8494A-02

Modification Recommended Service Note

8494A – Manual Step Attenuator

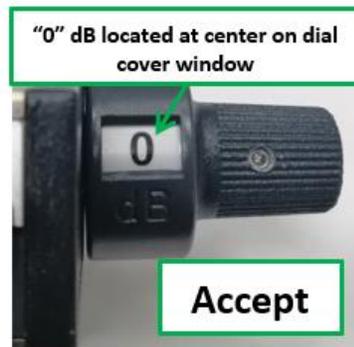
The attenuation knob was not securely tightened to the internal shaft, causing it to turn further. This is due to an insufficient torque that was applied to tighten the set screw during assembly at the factory.

- (1) Rotate the knob clockwise until it reaches the last attenuation step, which is at 0 dB.
- (2) Loosen the 2 set screws (0.05" Hex screw bit) on the knob slightly until the knob can freely move, and then align the knob so that the indicator label number "0" is located at center on dial cover window.
